SOUTH CAROLINA ELECTRIC & GAS COMPANY

Subject: Virgil C. Summer Nuclear Station
Docket No. 50/395
Operating License No. NPF-12
Reactor Coolant System Flow

South Carolina Electric and Gas Company hereby requests a revision to the Virgil C. Summer Nuclear Station Technical Specifications. This revision involves changes to Technical Specifications concerning the measurement uncertainty for the Reactor Coolant System (RCS) flow rate and defines allowable power levels for an RCS flow rate less than 100% of Thermal Design flow.

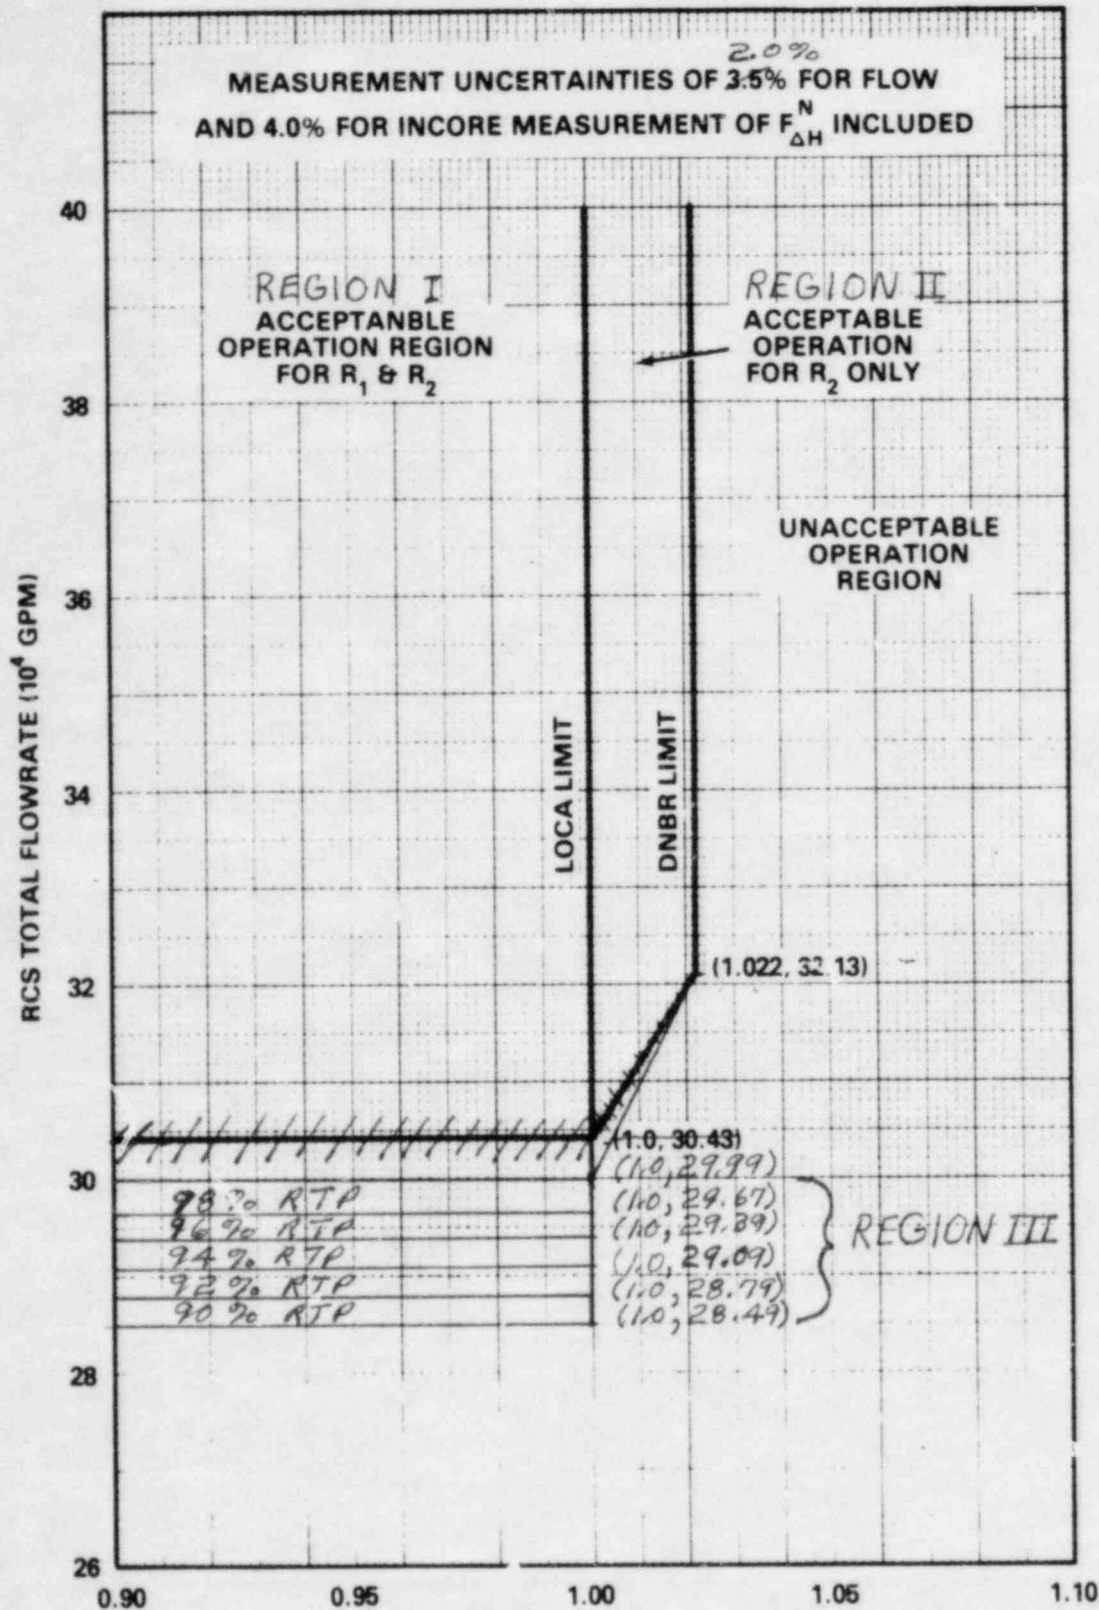
When RCS flow rate and $F_{\Delta H}^N$ are measured, no additional allowances are necessary prior to comparison with the limits of Figures 3.2-3 and 3.2-4. Measurement errors of ~~3.5%~~ ^{2.0%} for RCS total flow rate and 4% for $F_{\Delta H}^N$ have been allowed for in determination of the design DNBR value.

Figure 3.2-3 RCS FLOW RATE VERSUS R

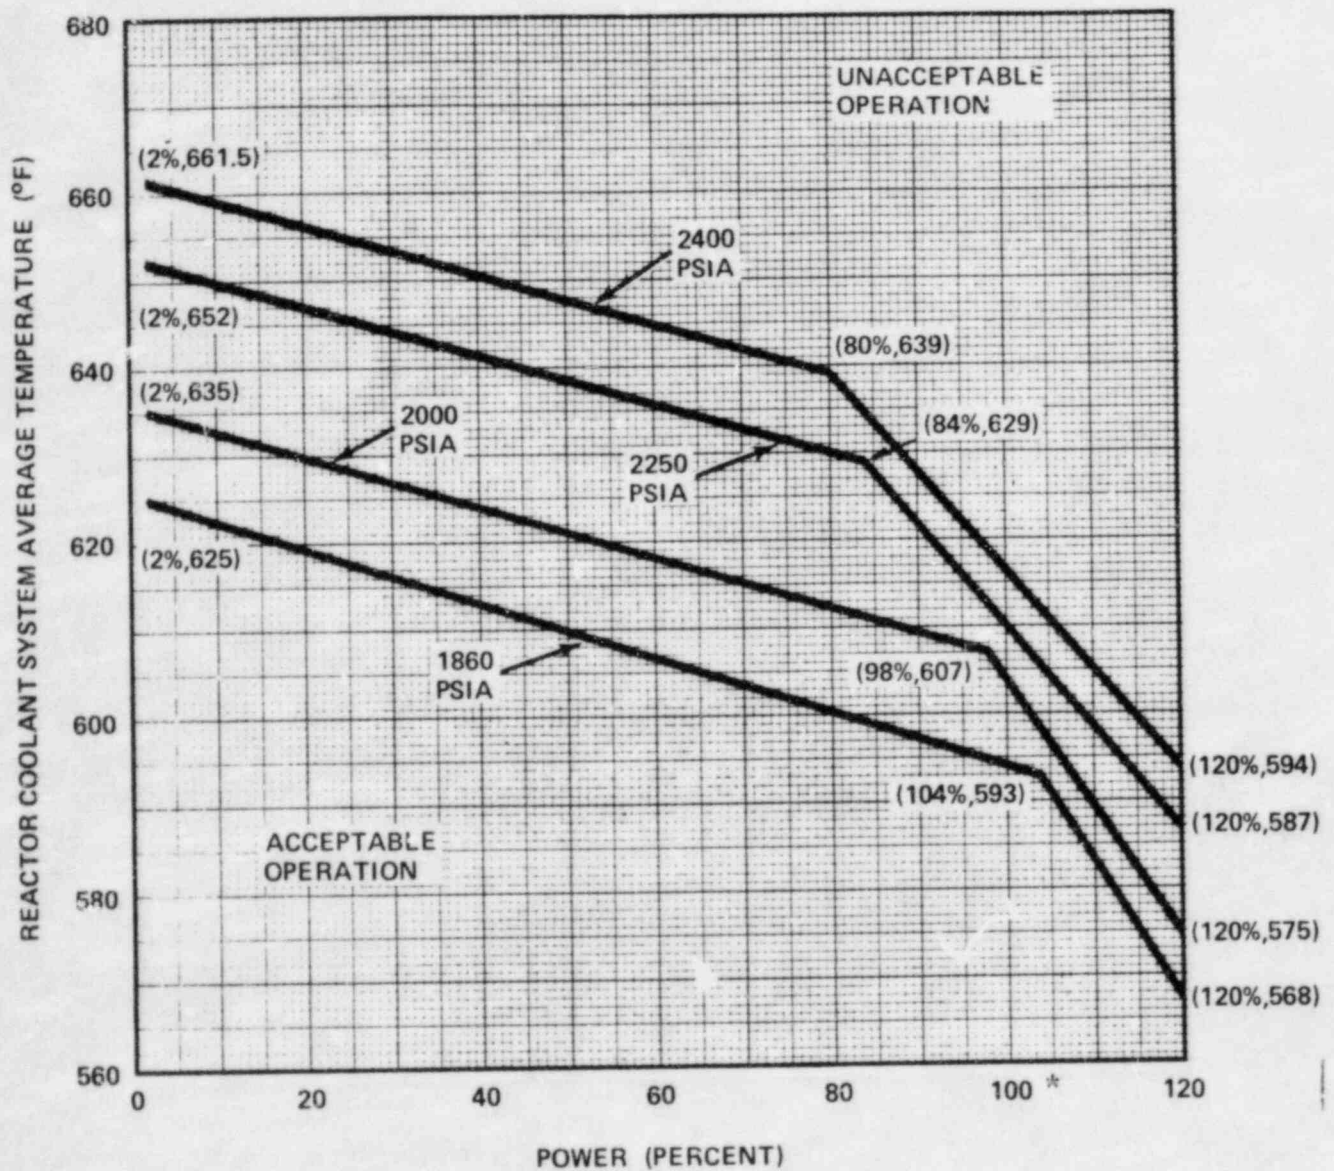
NOTE: When operating in Region III, the restricted power levels shall be considered to be 100% of Rated Thermal Power (RTP) for Figure 2.1-1.

Based on a conservative assumption that the measured RCS flow will be no lower than 95% of TD flow, it is requested that a region of acceptable operation be added to Figure 3.2.3 for:

Considering the relationship given by Equation 3, it is recommended that the maximum power level for this region be reduced by 2% for each 1% reduction in measured flow below TD flow. This conservative restriction of core power is the equivalent of an RCS flow increase ranging from approximately 2.6% - 13.0% in terms of DNB margin for flow deficits up to 5%. Operation of the plant in this region within the specified power restriction does not result in increased T_{avg} , thus there is no temperature impact on the DNB margin.

The proposed change to Figure 3.2-3 to account for a reduction in measurement uncertainties (3.5% to 2.0%) for RCS flow has no effect on the Thermal Design flow. The Thermal Design flow which is utilized in the various safety analyses remains unchanged. In regard to the change which defines allowable power levels for an RCS flow rate less than 100% of Thermal Design flow, thermal-hydraulic sensitivity studies have shown that this power/flow tradeoff is conservative with respect to DNB margin.

FIGURE 1

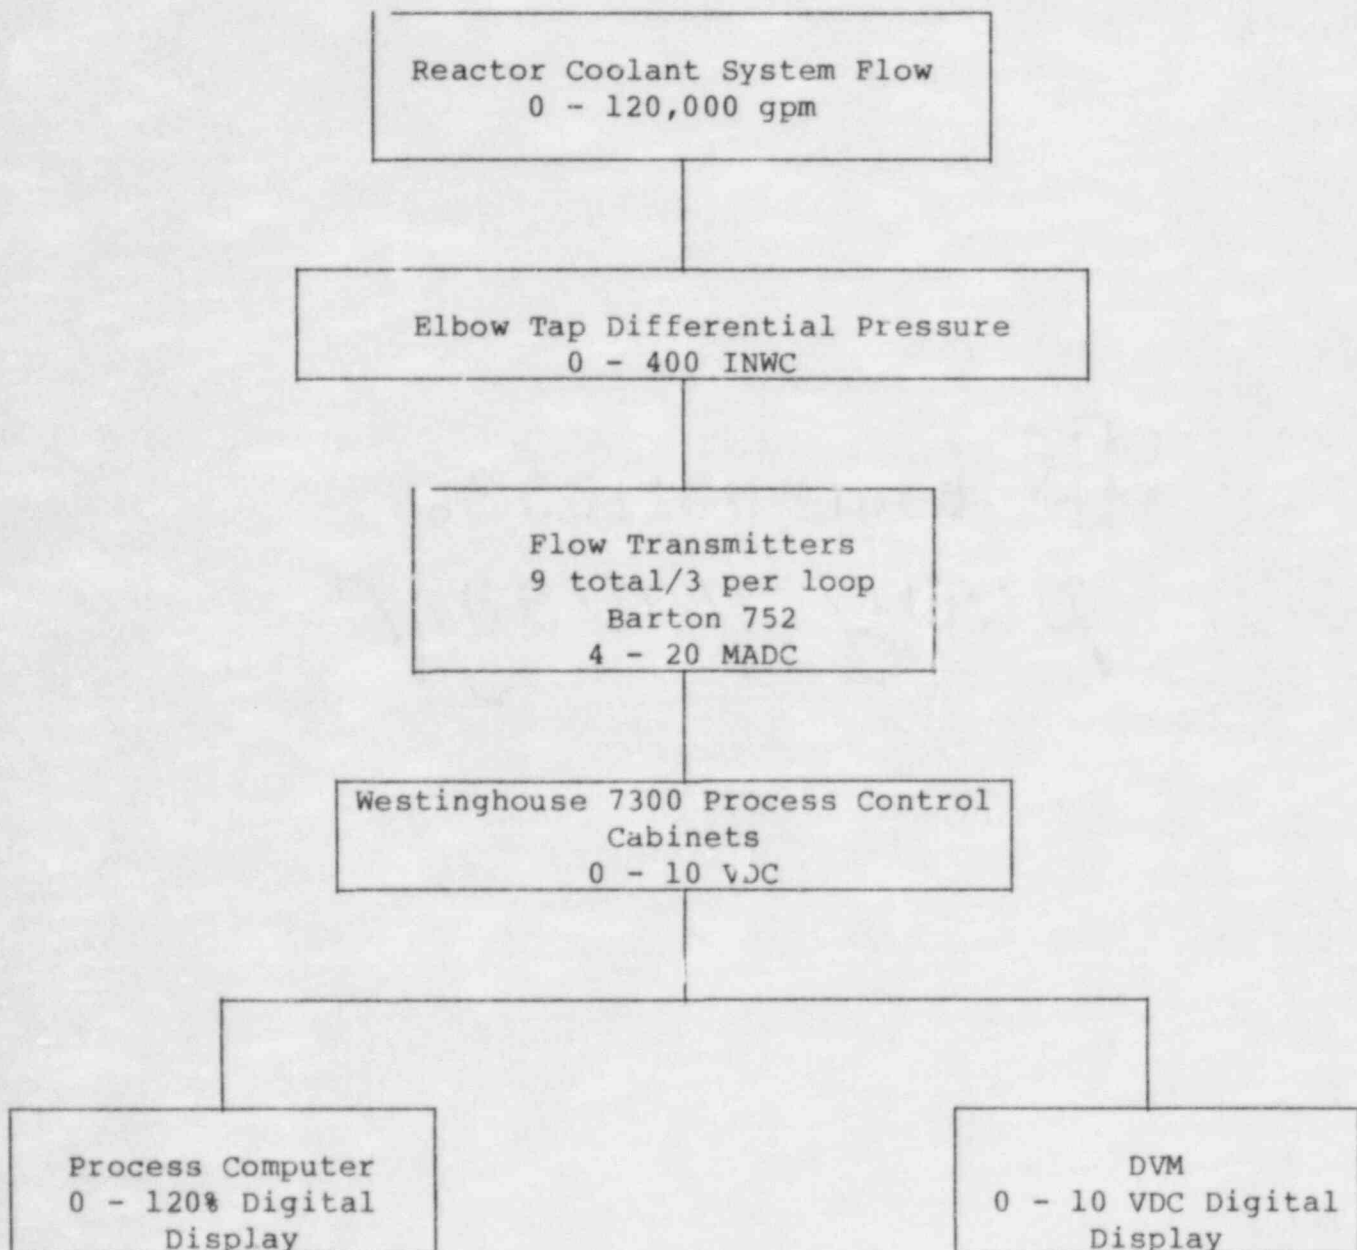
the elbow tap flow indication is depicted in Figure 1. Table 2 provides the list of components involved in the precision calorimetric flow calculations. The overall loop flow measurement uncertainty is the statistical summation of individual uncertainties (accounting for interactive effects where necessary) and appears at the bottom of Table 2
